EXPERT REBUTTAL REPORT
DEEPWATER HORIZON BLOWOUT PREVENTER
EXAMINATION AND TESTING

November 7, 2011

Prepared by:
The team of Talas Engineering, Inc.
20902 Cabot Blvd.
Hayward, CA 94545

An original report was submitted on August 26, 2011, and following is a rebuttal report, responding to comments and analysis offered by other experts in this matter. See the previous report for our expert qualifications and prior testimony. Attachments 4 through 7 provide recent updates to legal testimony by our experts.

Figure 1. Pipe wall tension forces for CASE A, annulus flow just before VBR closure

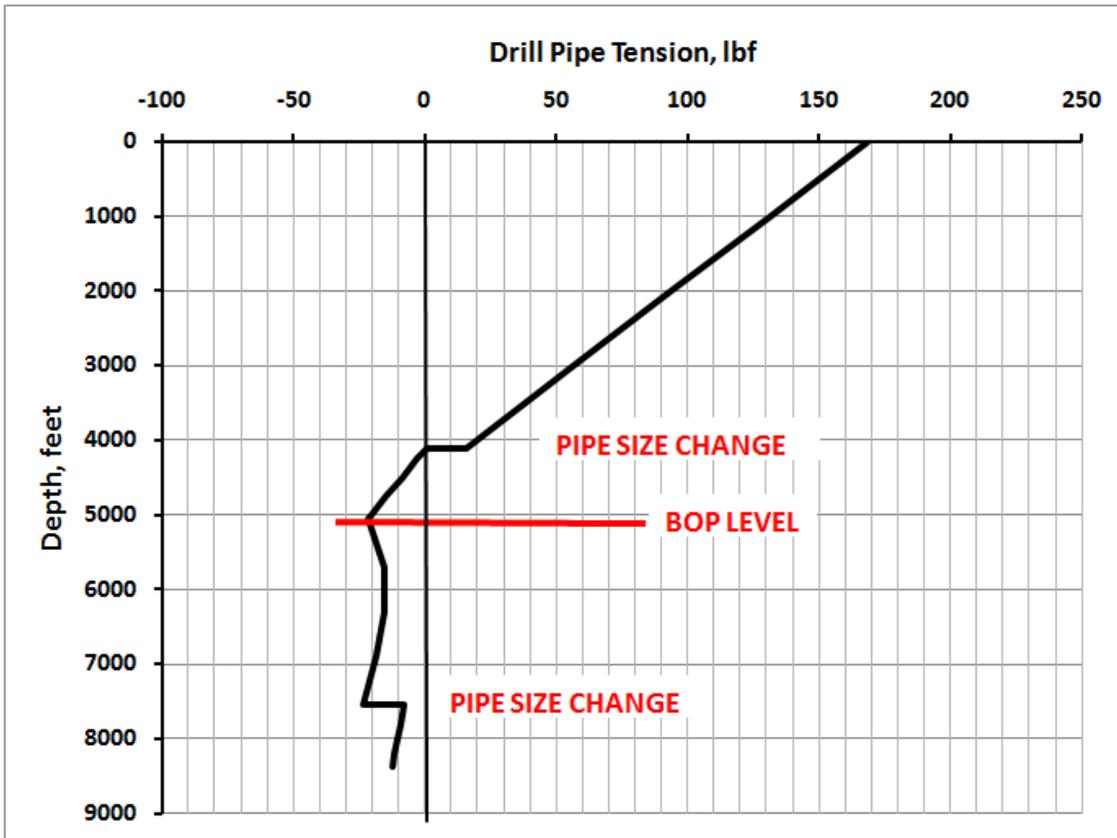
This analysis gives a resulting upward compression in the drill pipe walls at the VBR of 21.6 kip at this time. Using SES’s own blowout flow assumption, the forces are far less than the assumed 30-150 kip by SES in *Structural Analysis of the Macondo #252 Work String* [Ref. 3], and notably far less than any drill pipe Euler buckling force limit of more than 100 kip [Ref. 3 & 4].

Figure 1 shows the new drill pipe wall force variation with depth. Note that step force changes at pipe size changes are clear, and known to be present, but were not apparent in the SES work, for example Fig 3 of Reference 3. This is a clear indicator of incorrect analysis by SES.

Figure 2. Pipe wall tension forces for CASE B, no annulus flow just after VBR closure

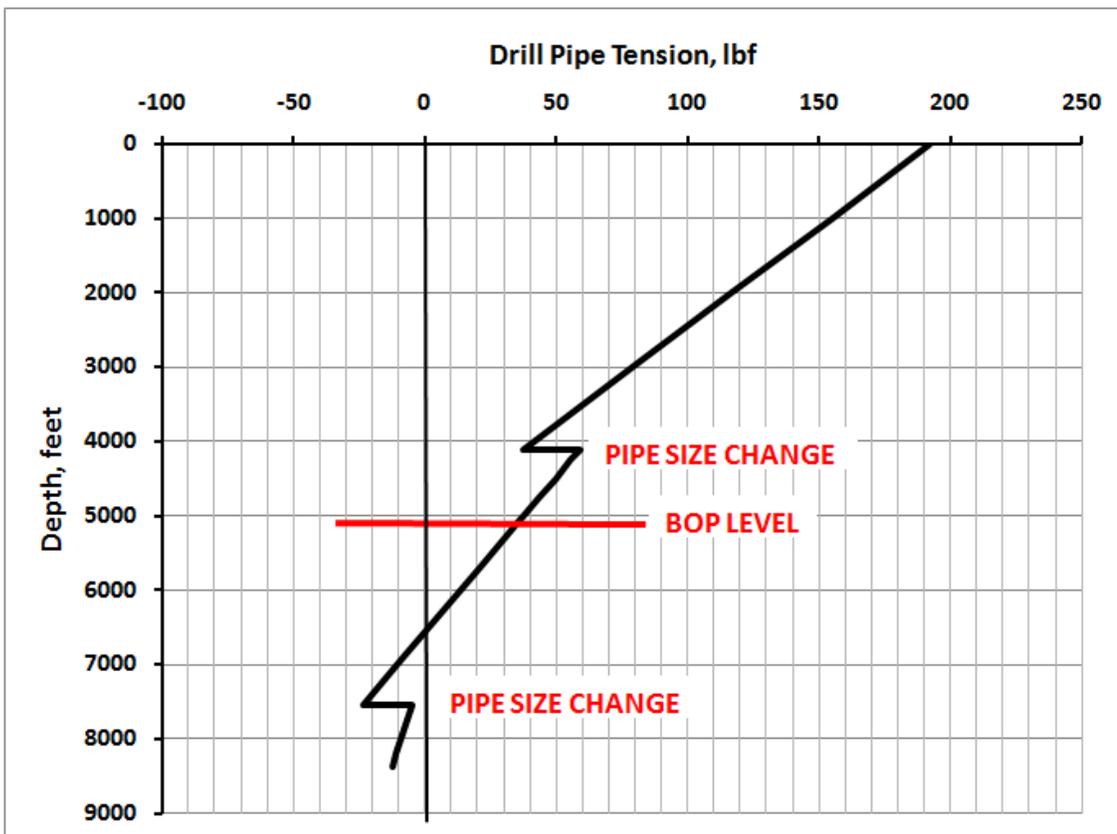
The CASE B analysis gives a resulting downward tension in the drill pipe walls at the VBR of 36.5 kip at this time. The forces are in the opposite direction than the assumed 30-150 kip compression by SES, and substantially so. [Ref. 3]

Figure 2 shows the new drill pipe wall force variation with depth for CASE B. Note that step force changes at pipe size changes are again clear, and known to be present. In fact the force step at the pipe transition above the BOP is reversed from the previous case.

Figure 3. Pipe wall tension forces for CASE C, no annulus flow a while after VBR closure

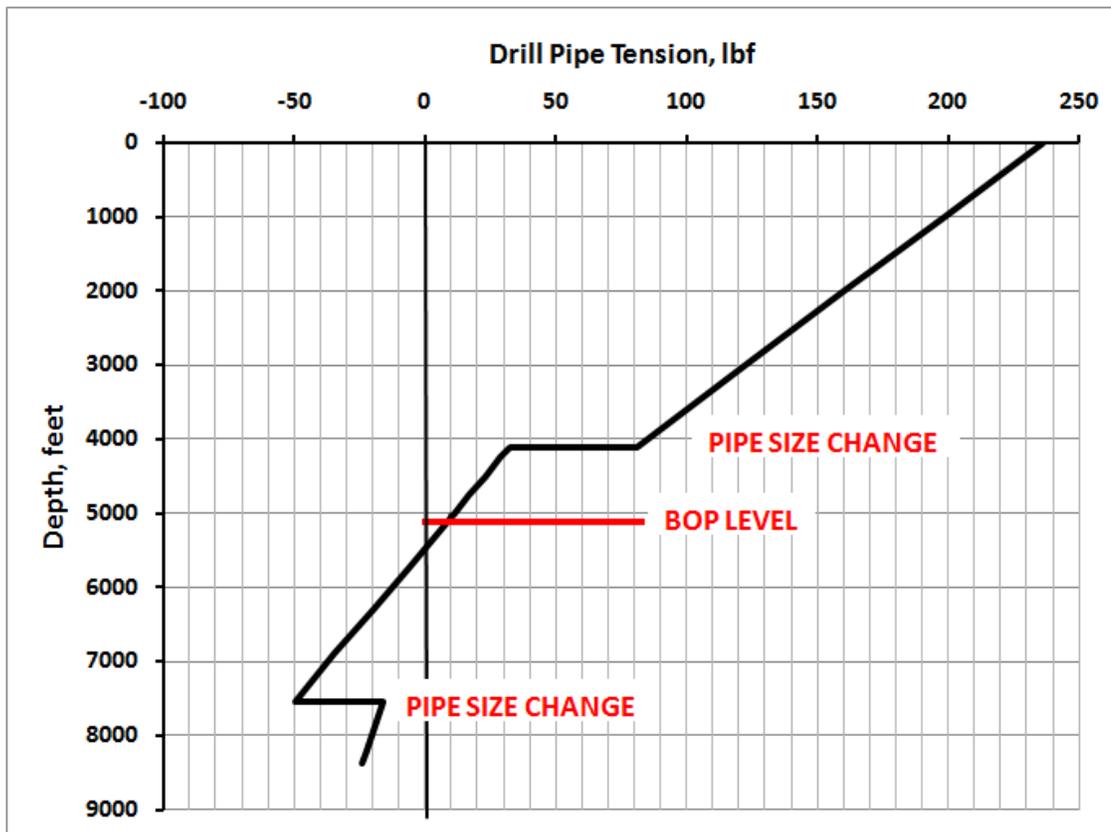
The CASE C analysis gives a resulting downward tension in the drill pipe walls at the VBR of 10.5 kip. The forces are in the opposite direction than the assumed 30-150 kip compression by SES. [Ref. 3 Figure 8]

Figure 3 shows the CASE C drill pipe wall force variation with depth. Note that step changes at pipe size changes are clear, and known to be present, but were not apparent in the SES work. The huge step in force at the closed VBR (and the VBR assumed to not hold axial force for this analysis for consistency with SES assumption) assumed by SES is erroneous and does not exist.

Figure 9. Erosion on the drill pipe at the UVBR (from page 82 of Reference 4)

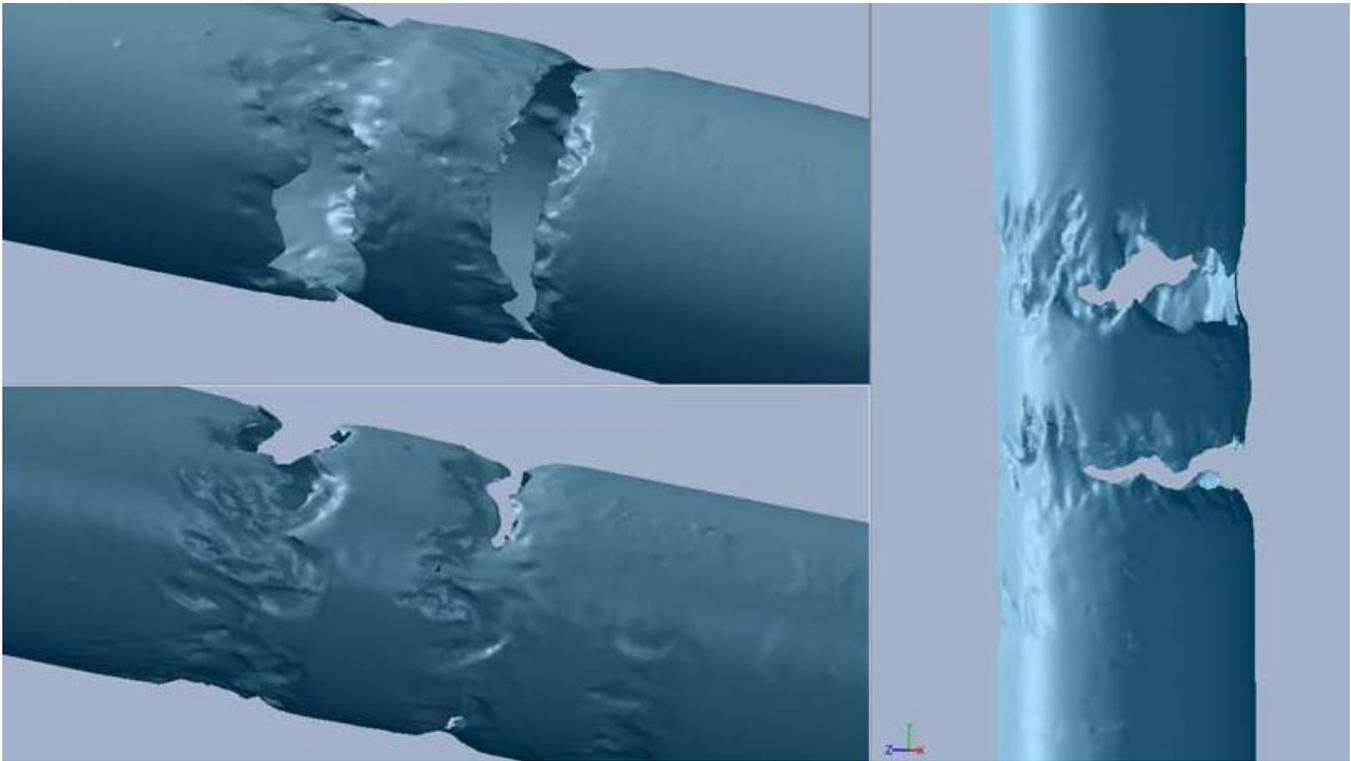
Further supporting evidence is provided by the erosion patterns on the drill pipe at the UVBR. These are distinctly asymmetric, indicating the two rams were closed to differing extents (see Figure 9). Note that the position of the locks as later measured at NASA Michoud is not indicative of their position at the time of the incident, because they had been cycled more than once between the time of the incident and inspection in New Orleans (see, for example Reference 8).

Figure 10. Centering Forces for variable friction and BSR blade design

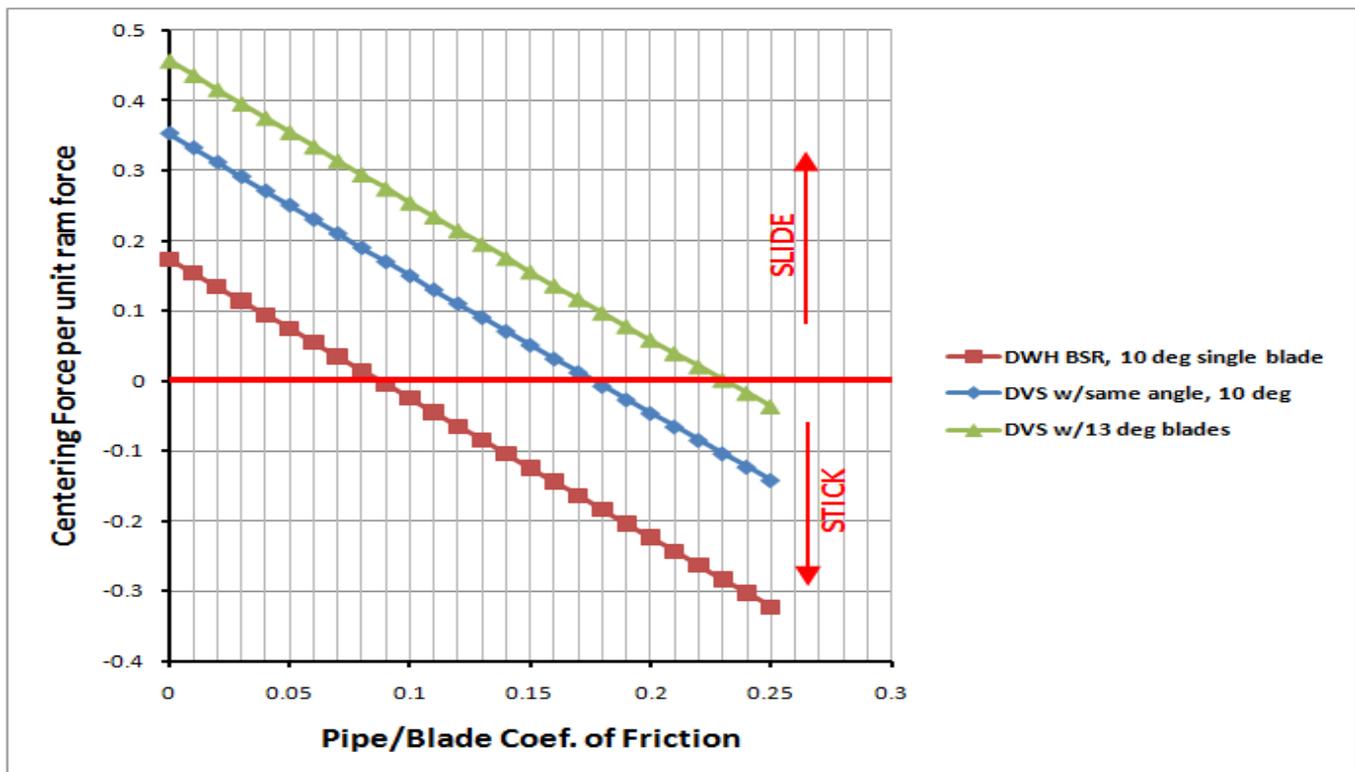
Figure 10 shows the resulting centering forces found, as a function of blade-on-pipe friction coefficient, for the existing Deepwater Horizon BSR (single V blade, 10 degree angle), a double-V BSR with the same blade angle, and another hypothetical double-V BSR with 3 degrees steeper blades. In this plot, negative centering force indicates the pipe will not slide, but rather stick.

A mildly surprising result is that the single V design will not slide the pipe at all if the friction coefficient is greater than about 0.09. This coefficient is lower than a typical dry steel on steel friction coefficient of 0.74 and lower than a reported lubricated steel on steel coefficient of 0.23 (lubricated with light mineral oil), and lower than steel on steel lubricated with castor oil - 0.15. [Ref. 18] At normally expected friction therefore, the pipe will stick and not center. Granted, the presence of fluids can help lubricate the contact and lower the friction, but once the blade digs in, that may not be significant. Also, the oil lubrication effect would be lesser as the blade roughness increases. It is admitted that knowledge of the friction is not good, but this friction limit is at the very least not comforting.

In contrast, the comparable double-V BSR design can tolerate a friction coefficient of up to 0.18 before sticking the pipe. This level is much more feasible to envelope steel on steel in the presence of lubrication of different levels (mud, water, or HCs), or none. In addition, the centering force for the double-V at a given friction coefficient is about double that of the single-V, which is not surprising. And increasing the blade angle 3 degrees increases the sticking friction level to 0.23 and the centering force another 30% over the double-V design.
